CERTIFICATE OF APPROPRIATENESS

Property: 909 Texas Avenue, Lots 1, 2, 6 through 10 & 12 and Tracts 3A & 11A, Block 57, SSBB Subdivision. The property includes a historic, brick, 518,000 square foot 18-story former hotel building situated on a 45,000 square foot corner lot.

Proposal: Alteration – Resubmittal: At the December 2014 HAHC meeting, the applicant was granted partial approval of a COA: approval of window alterations; denial of alterations to Texas Street entry including:

The applicant now proposes to replace the existing non-original front doors of the Texas Street entry with frameless glass doors.

3D RENDERING – FRONT FACING TEXAS STREET

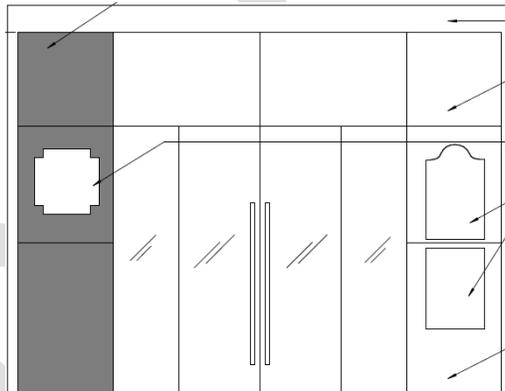
DENIED – 1/17/15

PROPOSED

SOUTH ELEVATION – FRONT FACING TEXAS STREET

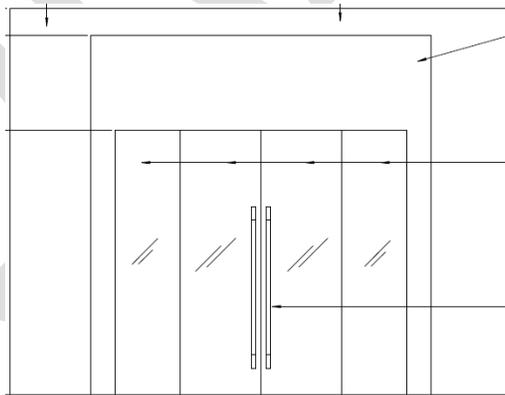
EXISTING

DENIED – 12/23/14

PROPOSED

Front Elevation: Existing wood entry doors and transoms will be removed and replaced with frameless glass doors
(South) with side lites.

**FIRST FLOOR PLAN
EXISTING**

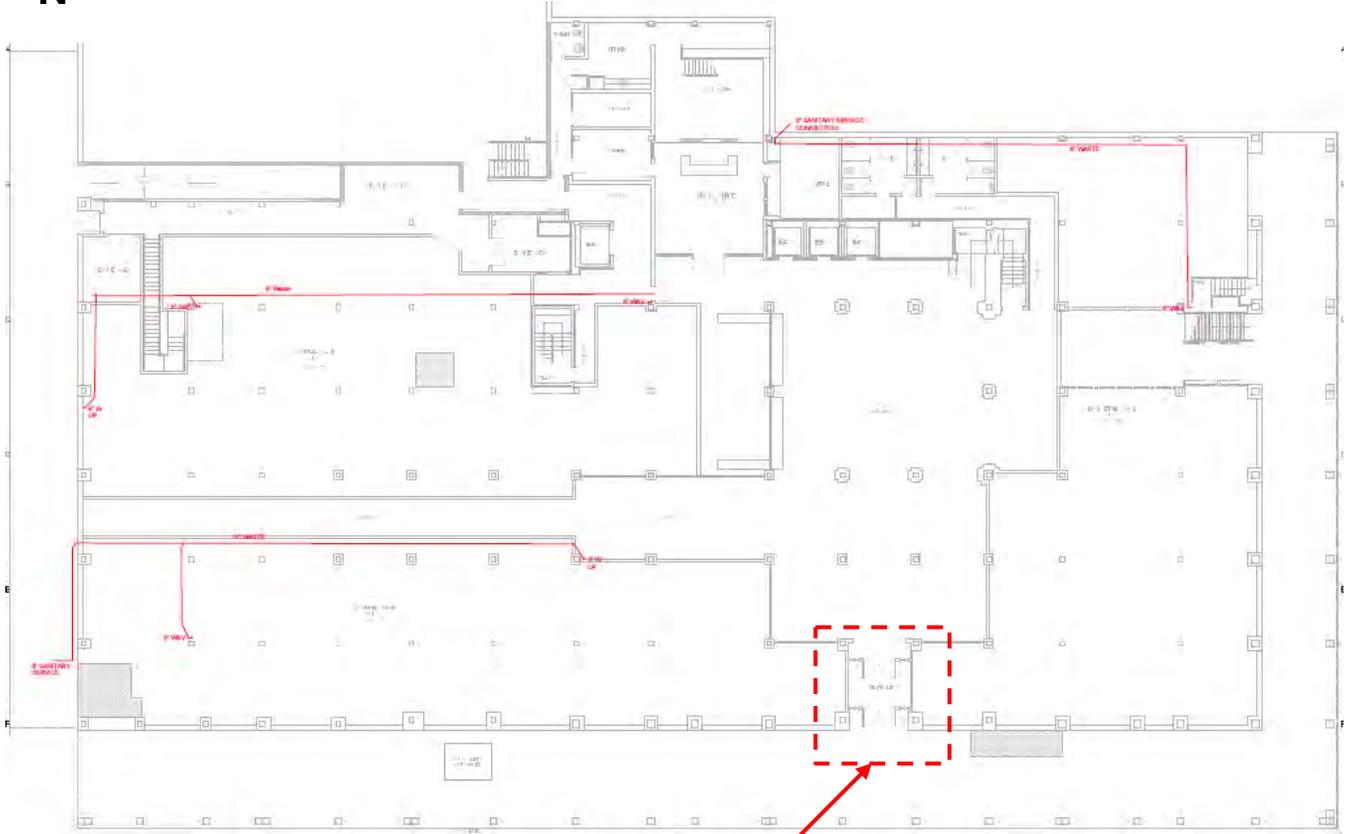
LOCATION OF PROPOSED ENTRY ALTERATION

Windows/Doors: The existing main entry on Texas Street features two non-original pairs of wood and glass doors with transoms to be removed and replaced with a pair of frameless glass doors with frameless side lites in the same 10'-10" wide by 9'-11" opening.
